As-built Baseline Monitoring Report FINAL

UT to Magness Creek Mitigation Project

DMS Project ID No. 100081

Response to DMS Comments (June 1, 2023) for DRAFT MY0/ As-Built Baseline Report and Record Drawing Review
UT to Magness Creek Mitigation Project, Cleveland County
Broad River Basin: 03050105
DMS Project #100081

Figure 3B

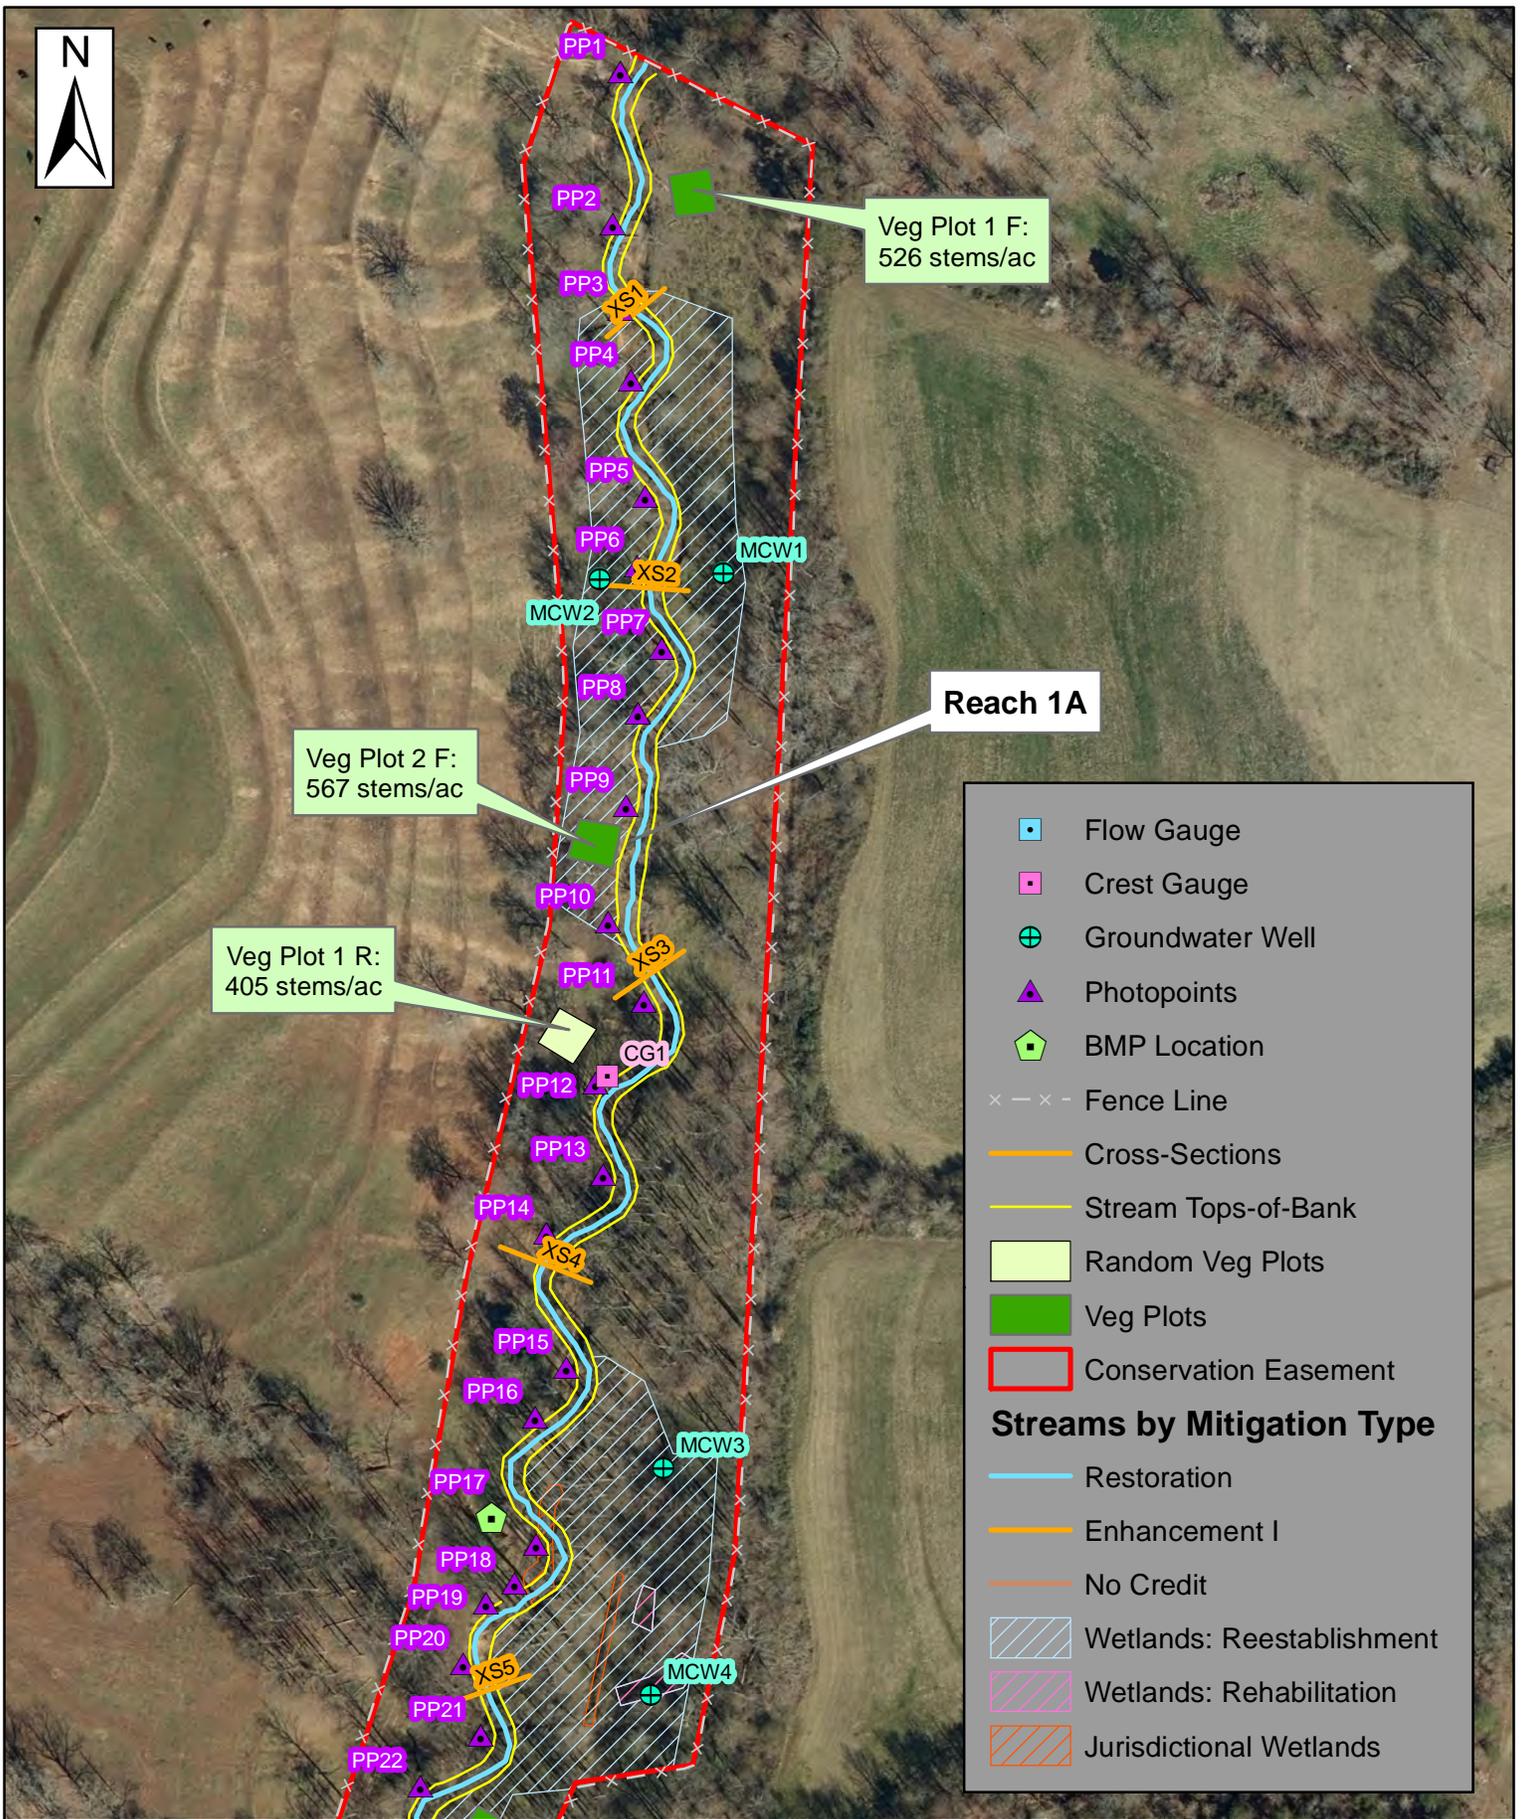
RESPONSE: These changes have been noted as requested.
- CCPV Figures/ Figure 3B: Please update the conservation easement shown on the CCPV maps to reflect the 0.028-acre partial conservation easement release recorded on 5/15/23. Figure 3B shows fencing located within the conservation easement.

RESPONSE: All figures have been updated as requested.

RESPONSE: There is currently no fencing installed within the project's conservation easement, which was confirmed by DMS staff during the May 30, 2023 site visit.

PROJECT REFERENCE NO. 167680	SHEET NO. 2D
PROJECT ENGINEER	
APPROVED BY:	
DATE:	
Michael Baker International	
<small>Michael Baker Engineering Inc. 8000 Regency Parkway, Suite 600 Cary, NORTH CAROLINA 27518 Phone: 919.463.5486 Fax: 919.463.5490 License #: F-1084</small>	
NC DMS ID NO. 10081

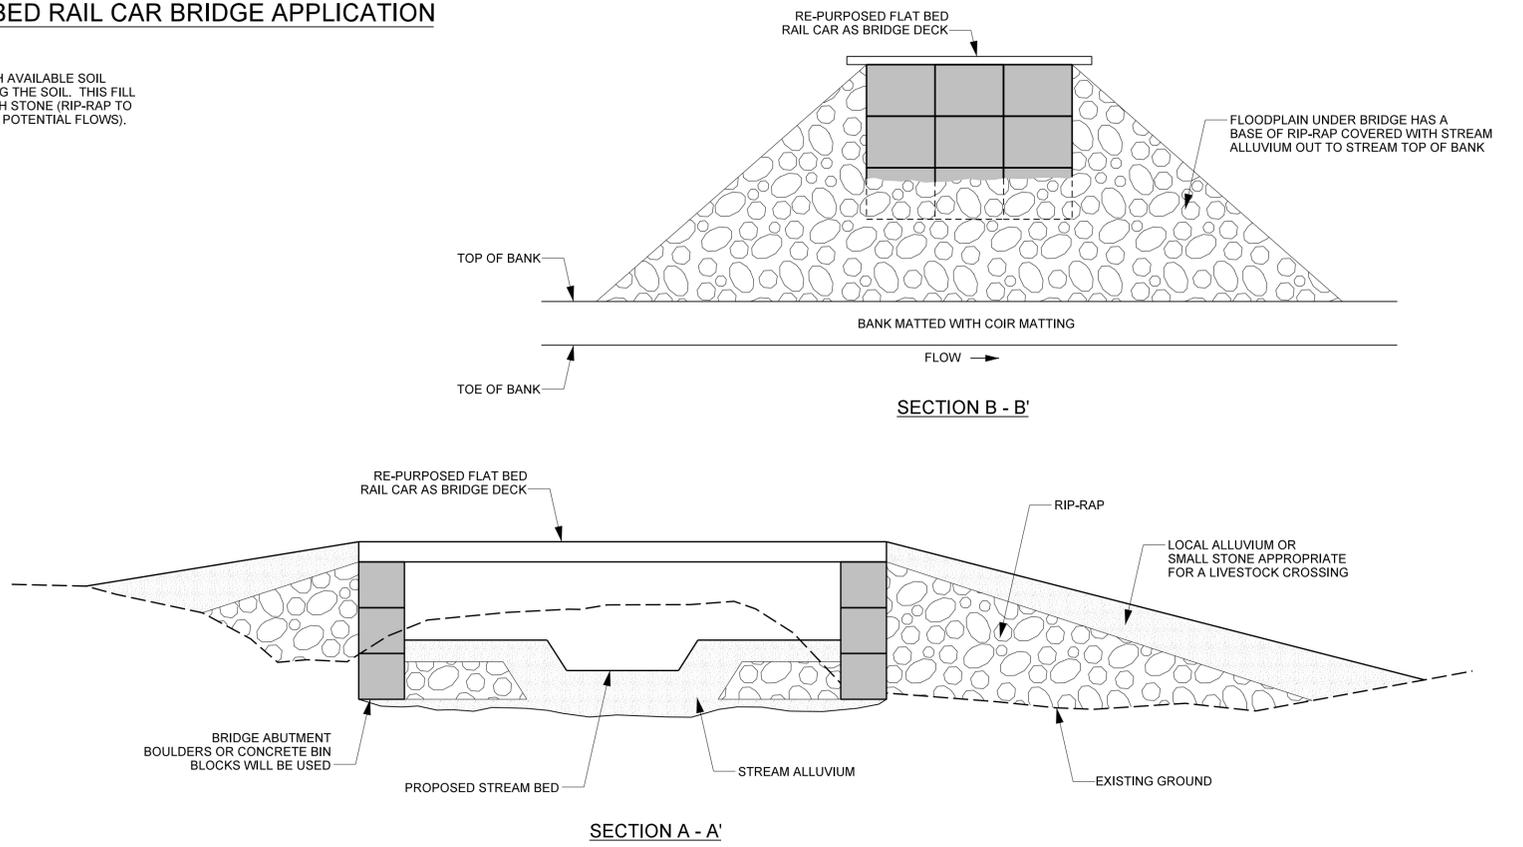
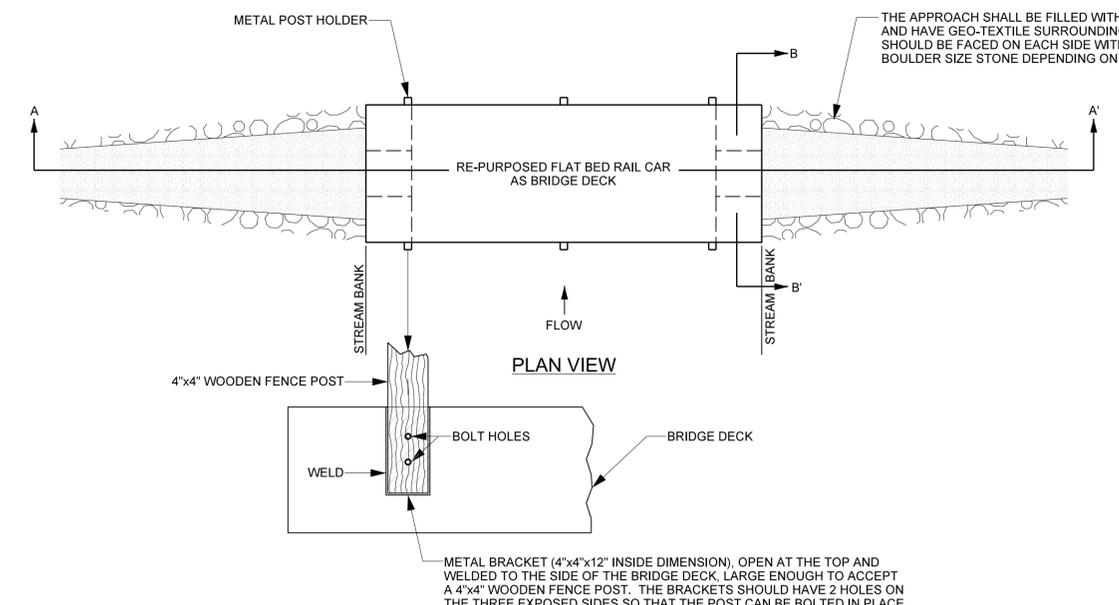
DMS and Baker are requesting that the IRT review a modification that Baker is planning for the originally proposed, culverted, stream crossing on UT to Magness Creek. Baker is now planning to use a bridge crossing. The proposed bridge crossing modification is located outside of the conservation easement and will not have an effect on the project credits. Fence posts and fencing will be attached to the bridge to limit livestock access to the bridge when crossing so they will not have access the creek.

Attached is a letter from Baker making the request, a copy of the modified plan sheet pages (2E & 8) and a couple of photos of this type crossing from the Russell Gap Mitigation Project (DMS#100003).

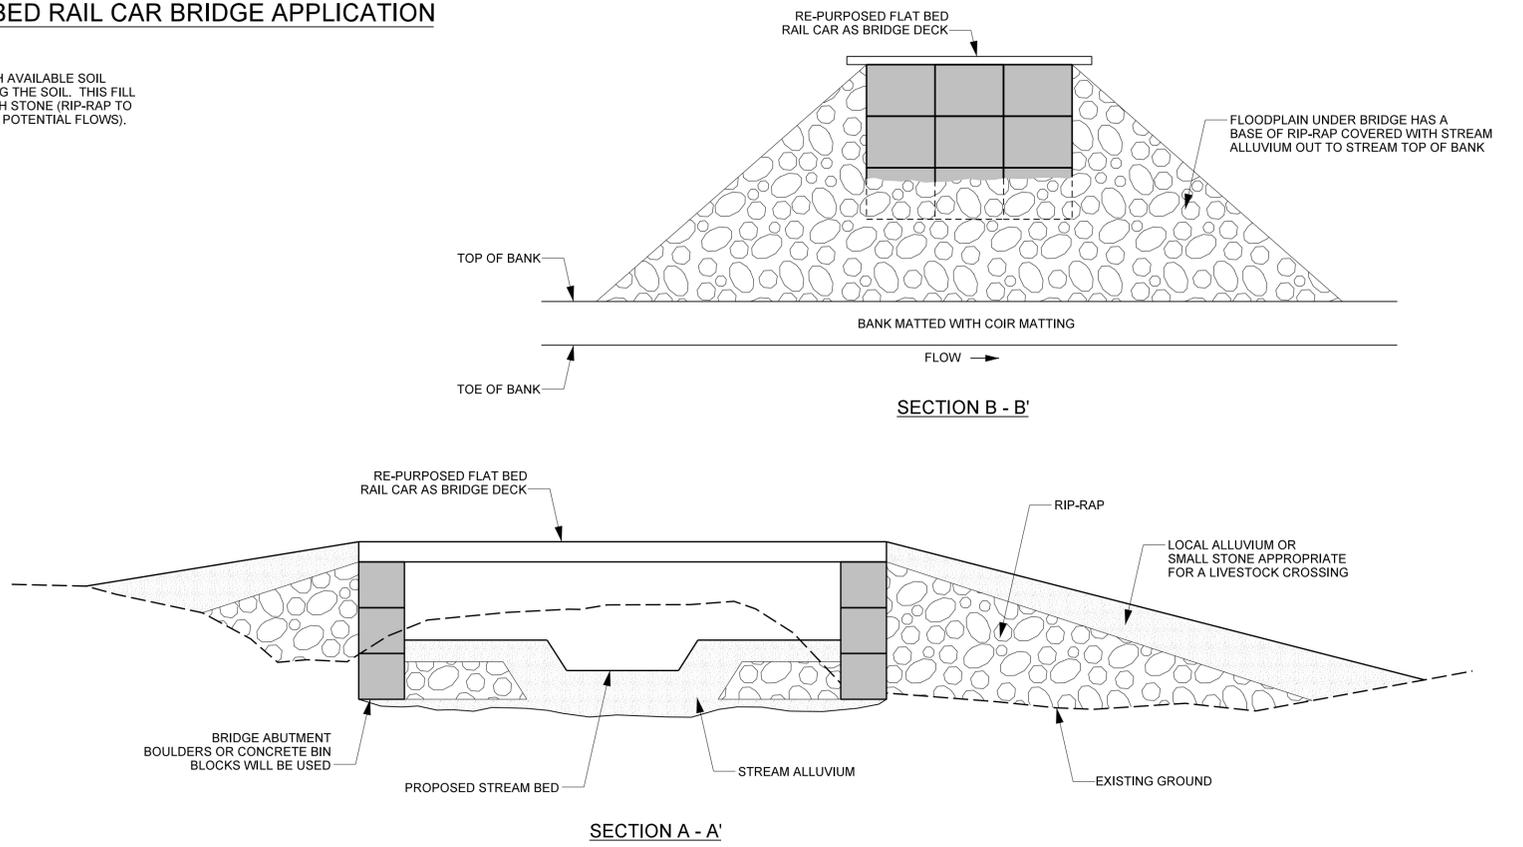
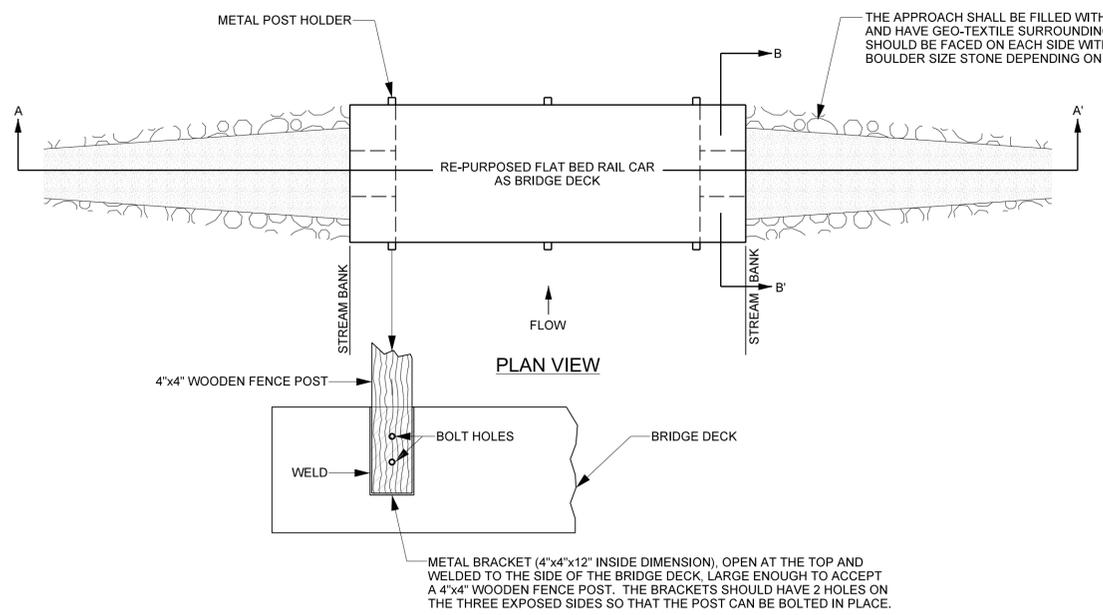
RESPONSE: These changes have been made as requested.
- Appendix F_Record Drawings_Sheet 2F: The Record Drawing detail sheets provided include a detail from a crossing that was eliminated from the project and does not include the bridge crossing detail as installed on the site. Please include the final bridge crossing detail in the revised Record Drawings.

RESPONSE: The Flat Bed Rail Car Bridge Application detail has been included on Sheet No. 2D.
- Appendix F_Record Drawings_Sheet 1A & Section 1.6 Design Change Deviations: Please review the vegetation selection portion of sheet 1A and confirm that there were no planting substitutions or changes from the IRT approved mitigation plan. Any project planting substitutions or changes from the IRT approved mitigation plan should be shown in "red" on the project's final Record Drawings. Eliminated species should have a line drawn through them and added and/or substituted species should be shown in "red" to detail the change. Any planting substitutions or changes from the IRT approved mitigation plan should also be detailed in the report text of Section 1.6 Design Change Deviations.
